To	:	All ASNs, FIA Technical Department and Competition Seat Manufacturers	Ref	:	FIASDH-17-003
From	:	Nuria Encinas	Pages	:	2
Date	:	20 June 2017	Subject	:	Labelling System for Competition Seats

New labelling system for re-validated competition seats

Figure 1: Re-validation label for seats complying with standard 8855-1999 re-validated after 01.07.2017

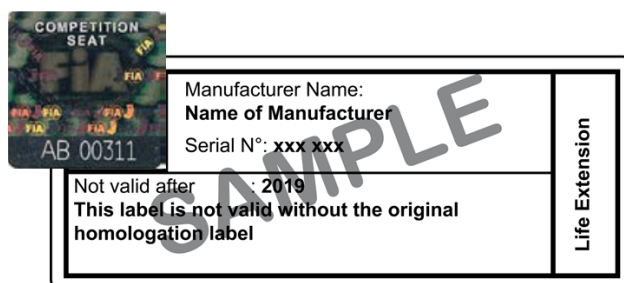
However, this re-validation labelling was not sufficiently counterfeit-proof.

For this reason, the FIA, together with the manufacturers, has decided to change the labelling of re-validated seats.

Existing homologation labels on all competition seats re-validated after 01.07.2017 will need to be complemented by an additional label in accordance with the template in Figure 1:
